**Federal Highway
Administration**

In Reply Refer To:
HSA-10/WZ-197 #1

This letter is in response to your company's correspondence through email requesting the Federal Highway Administration (FHWA) acceptance of your Type III Breakaway plastic barricades as crashworthy traffic control devices for use in work zones on the National Highway System (NHS). You requested that we find these devices acceptable for use on the NHS under the provisions of National Cooperative Highway Research Program (NCHRP) Report 350 "Recommended Procedures for the Safety Performance Evaluation of Highway Features." The purpose of this letter is to modify the previous WZ-197 letter issued by the FHWA dated March 22, 2005.

TYPE III BARRICADE ASSEMBLY DETAILS

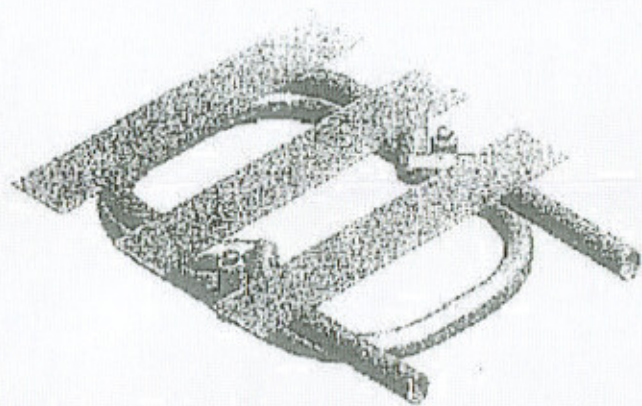
You indicate that Traffic Safety Service Corporation is now manufacturing the framing elements for your Type III Breakaway plastic barricade and that it is essentially identical to the previously accepted barricade issued by WZ-197. The framing elements of your Type III barricade are virtually identical in plastic formulation, material thickness, and hardware. The frame utilizes blow molded high density polyethylene that is manufactured using the same processes as before. When completely assembled the weight of the modified barricade is indeed 20 pounds, including the 3/16 poly panels which weigh 2 pounds each. The only difference, as shown in the enclosed drawings, is that the frame of the modified Type III Breakaway barricade has an indent on either side to aid in stacking and transport of the units.

Your modification to the successfully tested barricade only affects the barricade frame. Provided the rails are connected to the barricade frame in substantially the same manner as the tested barricade was assembled, your Type III Breakaway barricade described above and shown in the enclosed drawing for reference will be acceptable for use on the NHS under the range of conditions the original barricade was tested, when proposed by a State.

The FHWA agrees that the modified Type III Breakaway barricade is essentially identical to the previously accepted Type III barricade and that the small design difference will not affect its performance as a crashworthy device. Please note that the original Type III barricade was crash-tested with three rails on one side only and without lights. This acceptance is limited to the previously accepted crash test conditions.
